UNITED STATES  
NUCLEAR REGULATORY COMMISSION

May 24, 2000

SUBJECT SUMMARY OF APRIL 25, 2000, MEETING WITH THE BOILING WATER  
REACTOR OWNERS GROUP (BWROG) REGARDING APPENDIX R  
SAFE SHUTDOWN

**SUBJECT:** BOILING WATER REACTOR OWNERS' GROUP (BWROG)  
APPENDIX R FIRE PROTECTION COMMITTEE POSITION ON  
SAFETY RELIEF VALVES (SRVs) AND LOW-PRESSURE SYSTEMS  
(LPS) USED AS "REDUNDANT" SHUTDOWN SYSTEMS UNDER  
APPENDIX R (TAC NO. MA4745)

FIGURE 1A: SMALL FIRE WITH PROTECTION

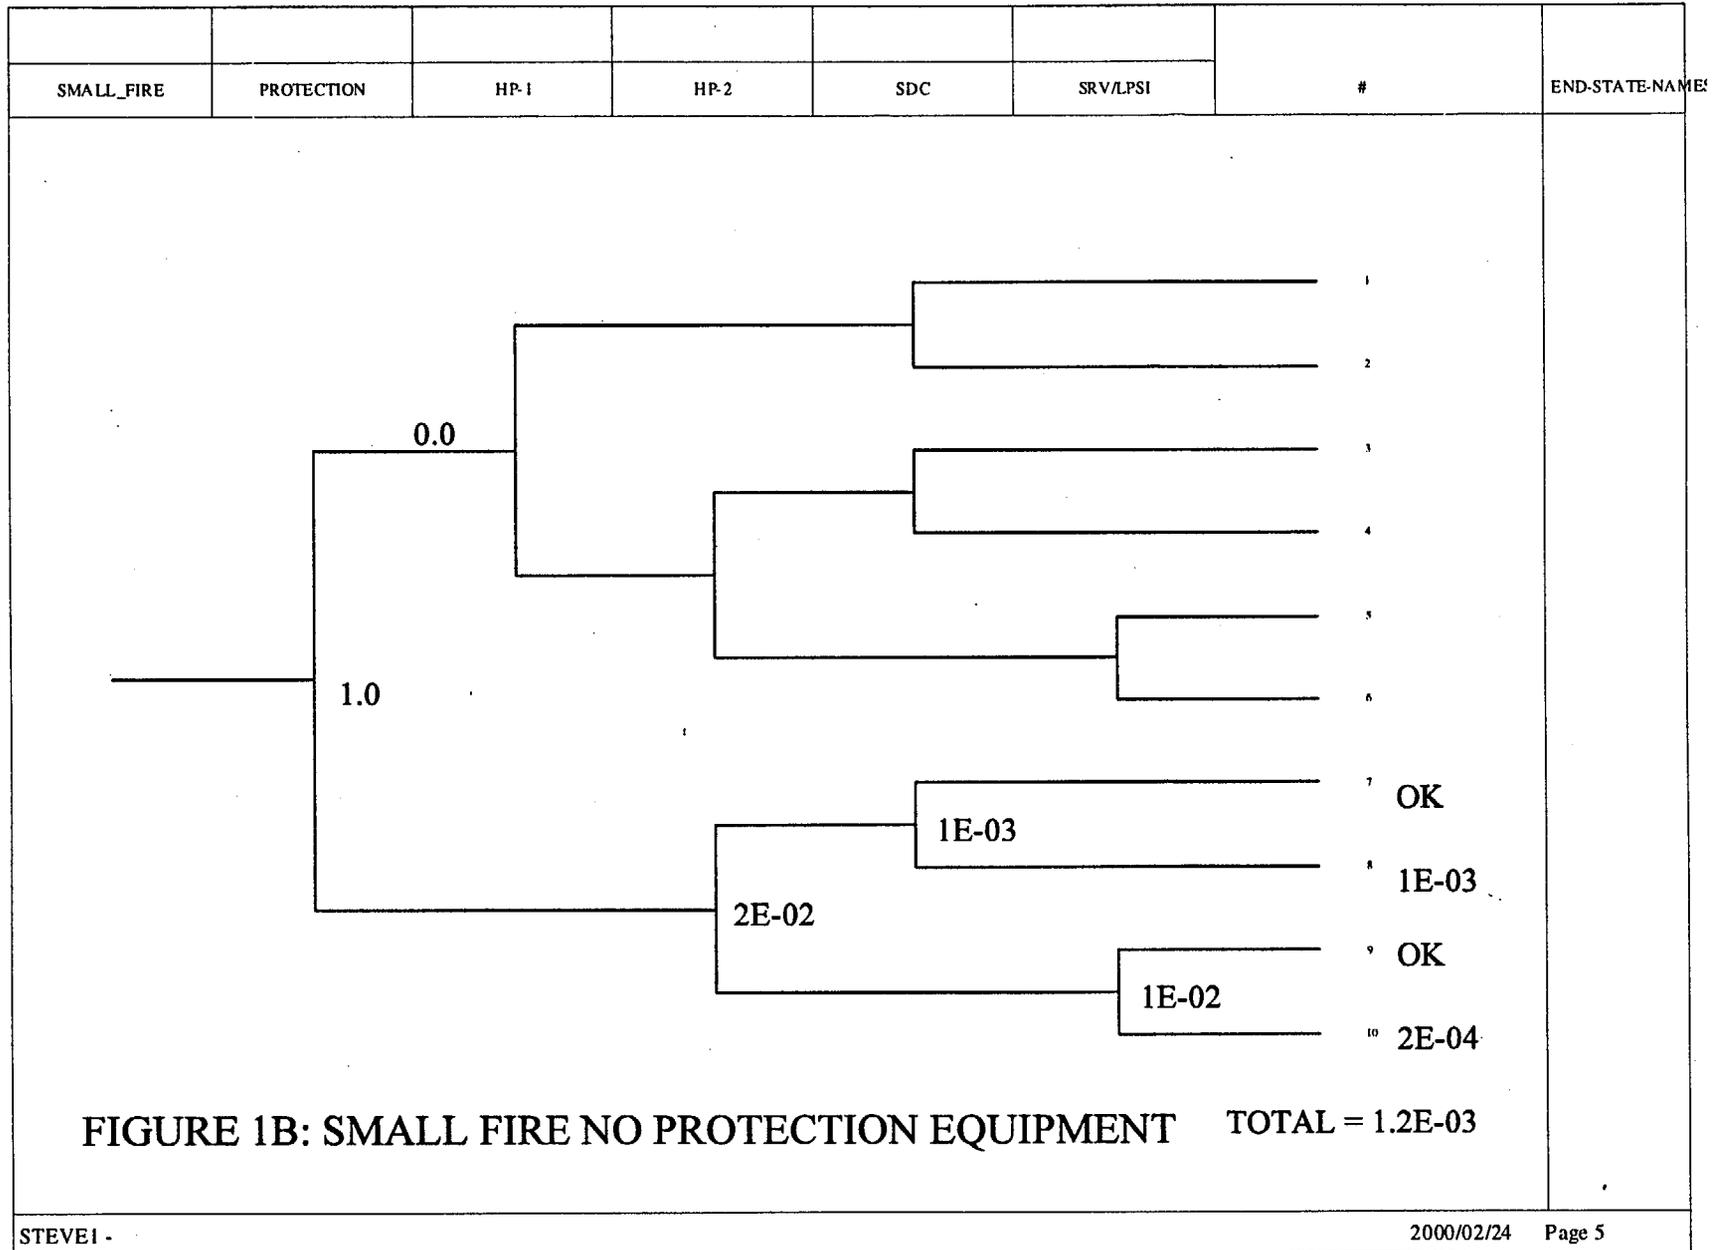
Event trees for small fires and large fires corresponding to the operability assumptions under 1.) above are given in Figures 1a and 1b, and Figures 2a and 2b. The (a) event trees were quantified for both with fire protection nominally available, and the (b) event trees without fire protection available. The following values were used to characterize the event tree events.

All calculations are done assuming a fire in a given area. That is, the estimates are core damage probability conditional on a fire in a given area. As illustrated by the figures, the following results are obtained

Small fire loads <i>with</i> fire protection in place:	1.0E-3 core damage probability given a fire
Small fire loads with fire protection removed:	1.2E-3 core damage probability given a fire
Large fire loads with fire protection in place:	1.7E-3 core damage probability given a fire
Large fire loads with fire protection removed:	1.0E-2 core damage probability given a fire

This indicates that removing the fire protection from areas with small fire loads has a negligible impact on the conditional core damage probability. Removing fire protection from areas with large fire loads may increase the conditional core damage probability by a factor of ten. Because the frequency of fire initiation is not affected by the fire protection features, the CDFs for each area would increase by the same factors.
